## **Process Sheet**

: CU-DAR001 Dart Helicopters Services

: INNER AFT SADDLE

: D5957

DART AEROSPACE LTD	Work Order:	28083
Description: Inner Aft Saddle	Part Number:	D5957
Inspection Dwg: D5957 Rev. A		Page 1 of 1

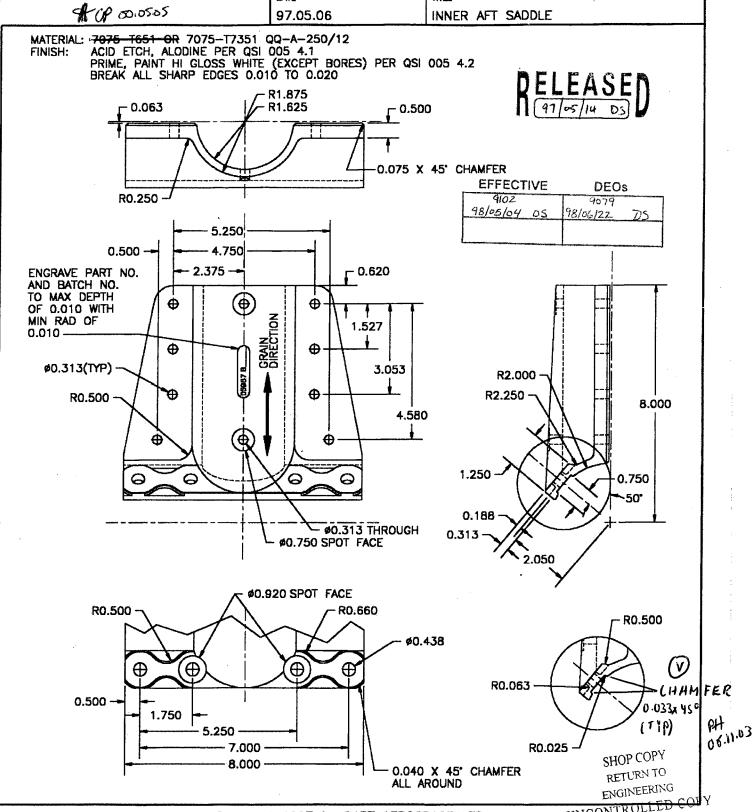
<u>, 5:</u>		WORK ORDER CHANGES					
DATE	STEP	PROCEDURE CHANGE	Ву	Date	Qty	Approval Mfg / Design Mgr	Approval QC Inspector
06-11:03	2	CHAMFER 0.033 x 45° WAS ADDED AND CALLED (). SIMFLEAD TO 0.1571.	06.11.63				E
		SEE ATTACHED					06.11.03

Last year we made a change to the ridges on the 205 saddles (we made a 0.033" X 45 degree chamfer) which I've attached.

Production is making a run of the extended high gear saddles D5951/D5953/D5955/D5957. Can the changes made to the 205 saddles be applied to the x-tended high gear saddles?

This change is acceptable to me.
